Interactive comment on “Geomorphometric delineation of floodplains and terraces from objectively defined topographic thresholds” by Fiona J. Clubb et al.

Fiona J. Clubb et al.

Received and published: 5 May 2017

Fig. 1. Shaded relief map of the Clearwater River, WA, showing combined floodplains (blue) and terraces (red)

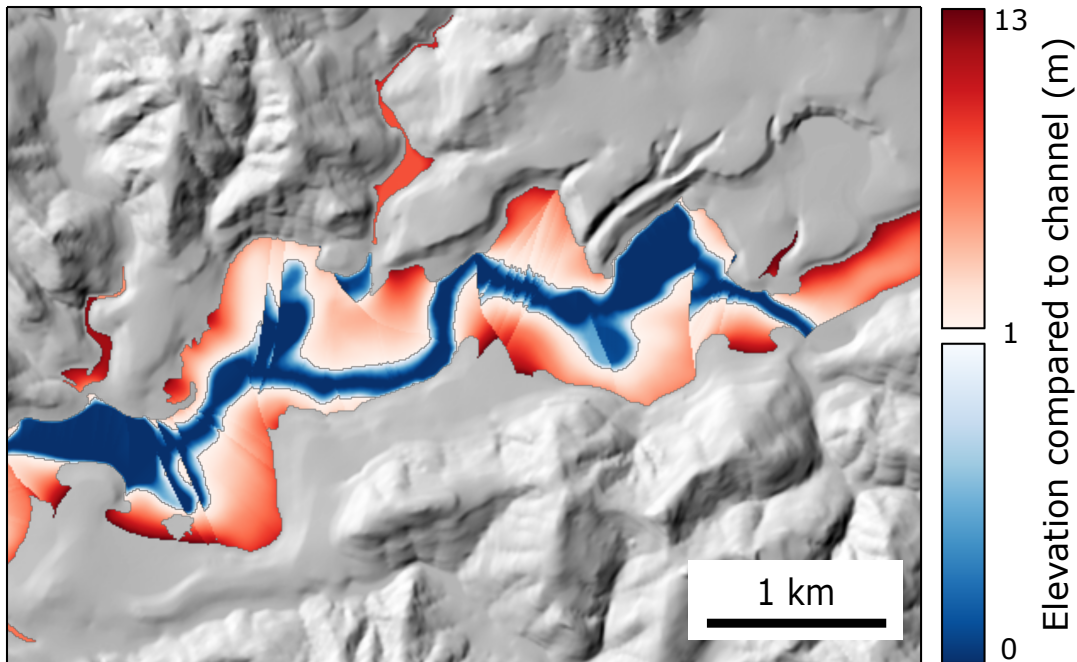
7. *Figures The figures are clear and well described. Just a curiosity: figure 8c and d: the predicted terrace is quite different from the digitised one in the central part of the river. From a visual inspection, this appears as a quite well define terrace, what is this difference's cause? Also, is it possible to have a map of an area showing both the identified terrace and floodplain?*

We have not included the combined floodplain and terrace maps into the paper, as we want to keep the sections on floodplain and terrace identification separate to fit in with the overall structure of the paper. However, we include the combined map for the Clearwater River here for reference.
